REVISIONS TO THE SCDOT SEISMIC DESIGN SPECIFICATIONS FOR
HIGHWAY BRIDGES
April 2022

The revisions included herein shall apply to the SCDOT Seismic Design Specification for Highway Bridges and Bridge Design Memorandum DM0115.

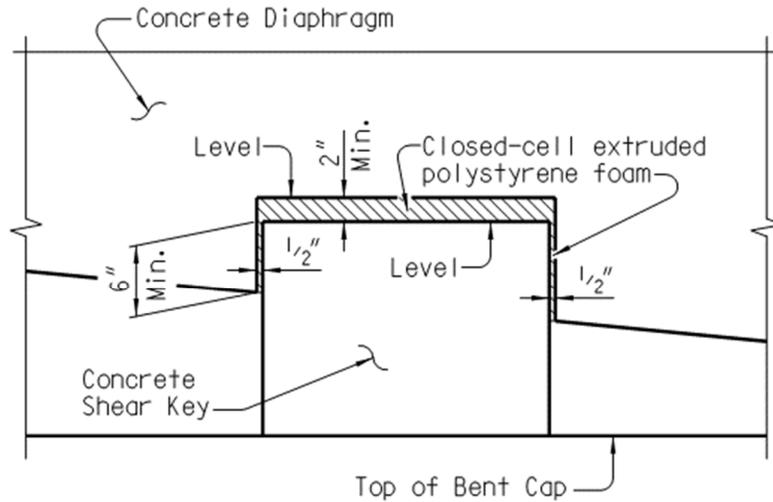
Page 3, Notes after Equation (7-3b) and “Where” on page 3 are replaced with the following:

μ_c is the local member ductility capacity, see Figure 6.3 & 6.5.

μ_{c1} is the local member ductility capacity of first cantilever segment, see Figure 6.4 & 6.6

μ_{c2} is the local member ductility capacity of second cantilever segment, see Figure 6.4 & 6.6
